# Access Compliance Report

Intersection ID: 14356	Main Street: BAXTER_ST	Cross Street: S_TORRENCE_ST	Location: N
ADA ID: 939CF533EF5F	Ramp Type: BlendTrans2	Initial Pass/Fail: Fail	Overall Compliance: No
			Severity Score: 21.25

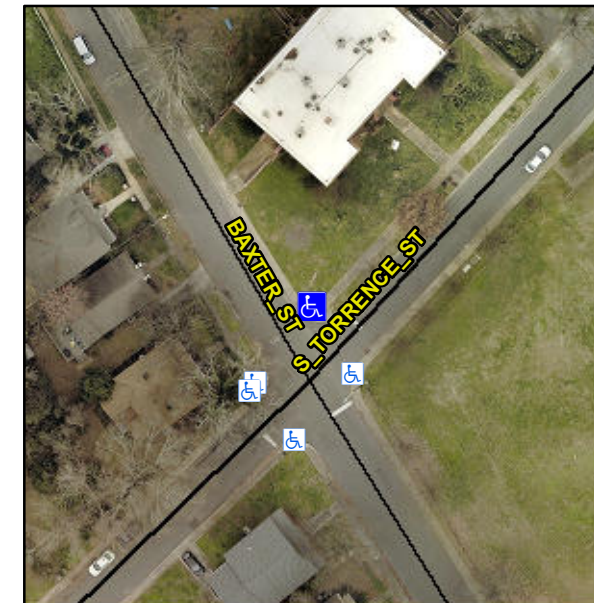
**Not Found, R304.5.1, R304.5.3**

Compliance	Description	Data	Compliance	Description	Data
N/A	Ramp Length (in)	70.0	Yes	BlendTrans Slope (%)	4.5
No	Ramp Width (in)	45.0	No	BlendTrans XSlope (%)	5.2
N/A	Flare Type LT	N/A	N/A	Flare Type RT	N/A
N/A	Flare Slope LT (%)	N/A	N/A	Flare Slope RT (%)	N/A
N/A	Flare Traversable LT?	N/A	N/A	Flare Traversable RT?	N/A
N/A	Landing Length (in)	N/A	N/A	DWS Provided?	N/A
N/A	Landing Width (in)	N/A	N/A	DWS Contrast?	N/A
N/A	Landing Slope (%)	N/A	N/A	DWS Length (in)	N/A
N/A	Landing X Slope (%)	N/A	N/A	DWS Full Width?	N/A
N/A	Landing Curb? (Y/N)	N/A	N/A	DWS Offset (in)	N/A
N/A	Shared Landing?	N/A			
N/A	Gutter Ponding?	N/A	N/A	Gutter Slope (%)	N/A
N/A	Gutter Lip Ht (in)	N/A	N/A	Gutter X Slope (%)	N/A
N/A	Painted X Walk1?	No	N/A	Painted X Walk2?	No
	X Walk 1 Direction	To SW		X Walk 2 Direction	To SE
	X Walk 1 Width (in)	N/A		X Walk 2 Width (in)	N/A
	X Walk 1 Slope (%)	2.3		X Walk 2 Slope (%)	5.2
	X Walk 1 X Slope (%)	2.6		X Walk 2 X Slope (%)	3.2

N/A	Ramp inside XWalk1?	N/A	N/A	Ramp inside XWalk2?	N/A
	Road Slope (%)	4.3		Clear Space?	N/A
	Road X Slope (%)	2.6	N/A	Clear Space to XWalk (in)	N/A
N/A	Any Obstructions?	N/A	N/A	Storm Grate/Utility Hazard?	N/A
	Obstruction Type			Storm Grate/Utility Type	
		N/A			N/A
			Yes	Surface Condition? (G/P)	Good
			No	Curb Slope (%)	18.5

**Remove & Replace Curb Ramp With Two New Directional Ramps or Equivalent.**
